Re: Initial Submission Review: Possum Gully Channel and Pond – Infrastructure Site Plan and Final Plat
Application Number: DA-1746-23
Case Numbers: 2020-6012-00; 2020-3015-00

First Submission Review

MHFD Referral Review Comments

Project Name:	High Point East – Possum Gully and Pond PG0
Location:	Aurora
Drainageway:	Possum Gully

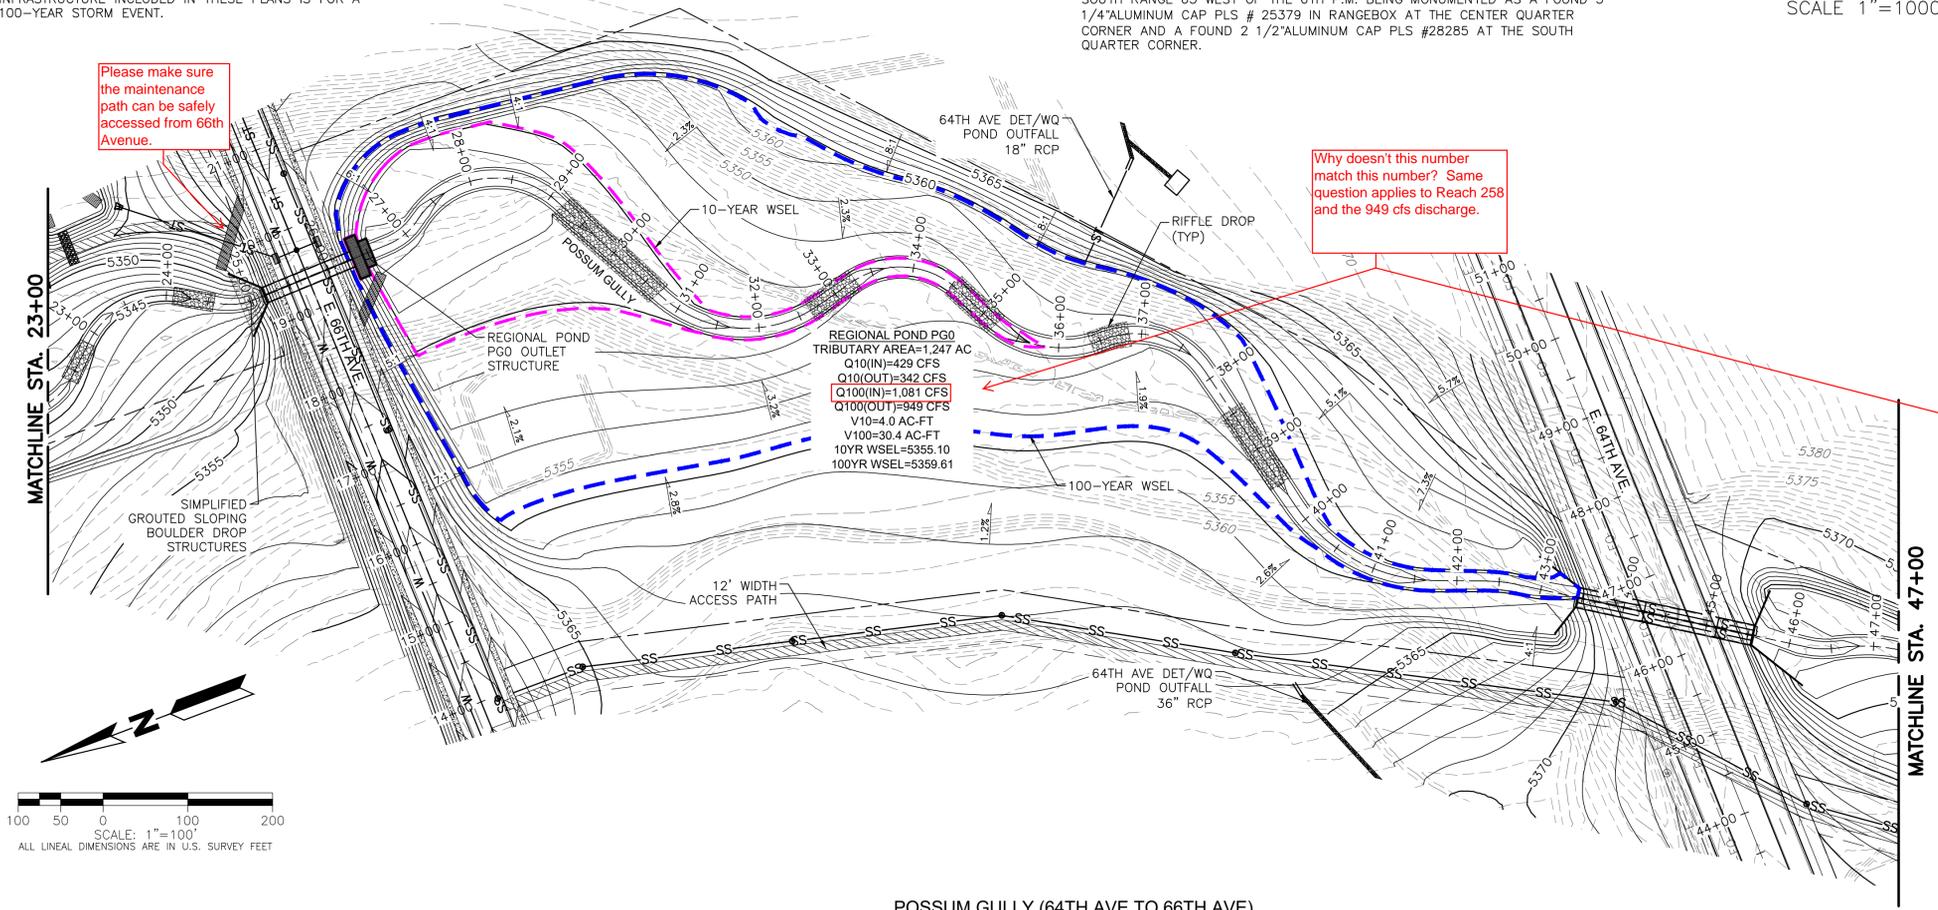
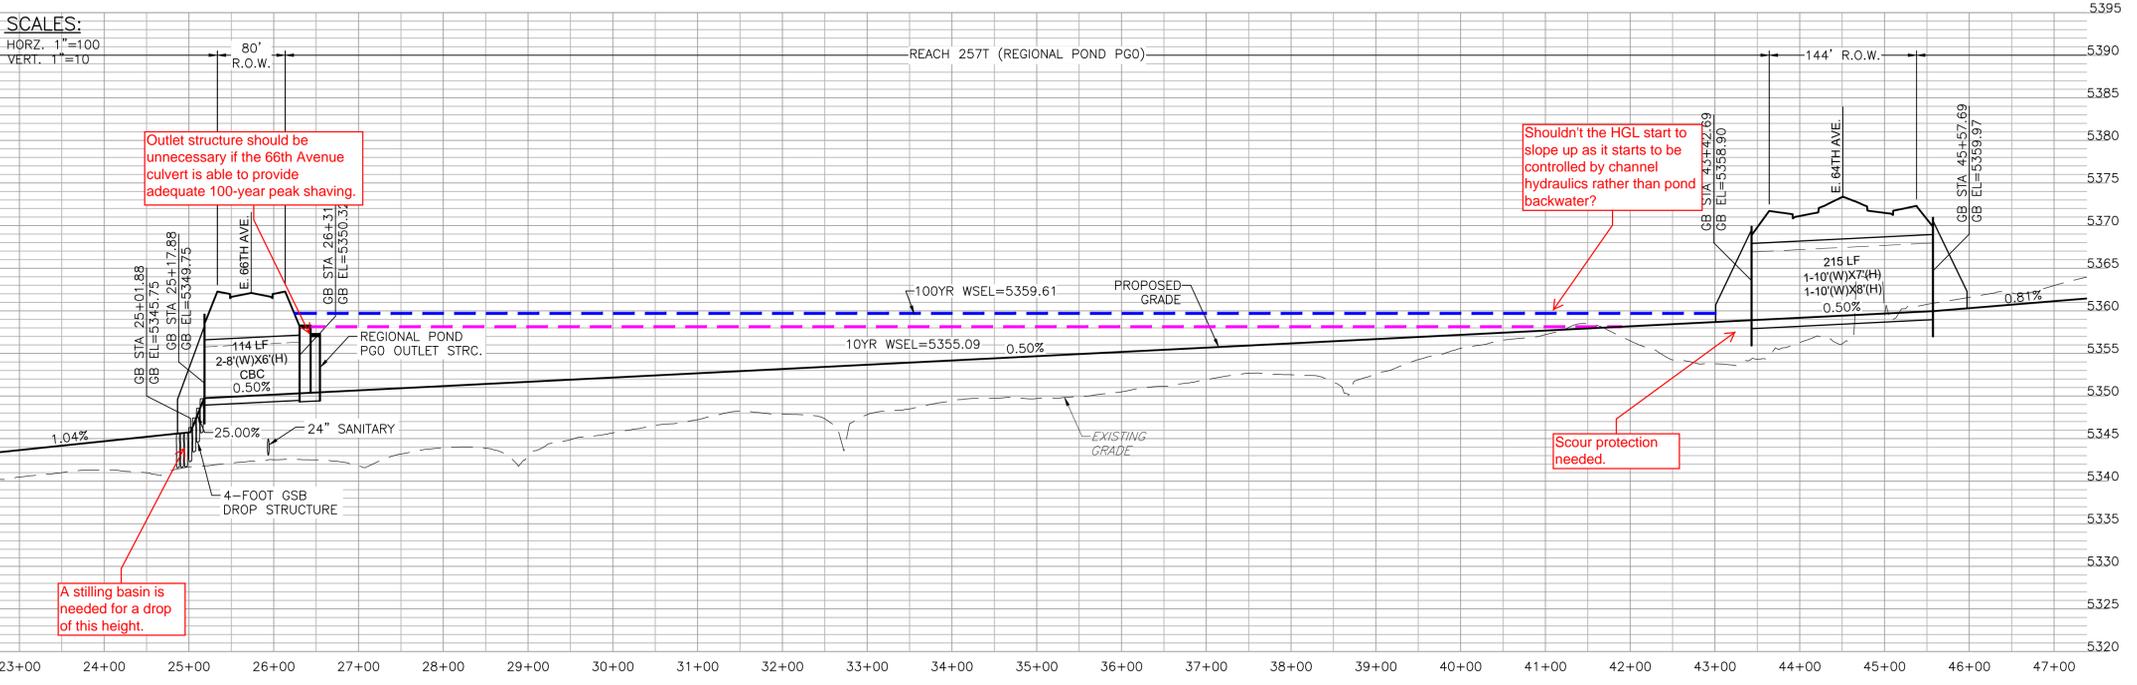
Please make sure the maintenance path can be safely accessed from 66th Avenue.

Why doesn't this number match this number? Same question applies to Reach 258 and the 949 cfs discharge.

Outlet structure should be unnecessary if the 66th Avenue culvert is able to provide adequate 100-year peak shaving.

Shouldn't the HGL start to slope up as it starts to be controlled by channel hydraulics rather than pond backwater?

Scour protection needed.

A stilling basin is needed for a drop of this height.
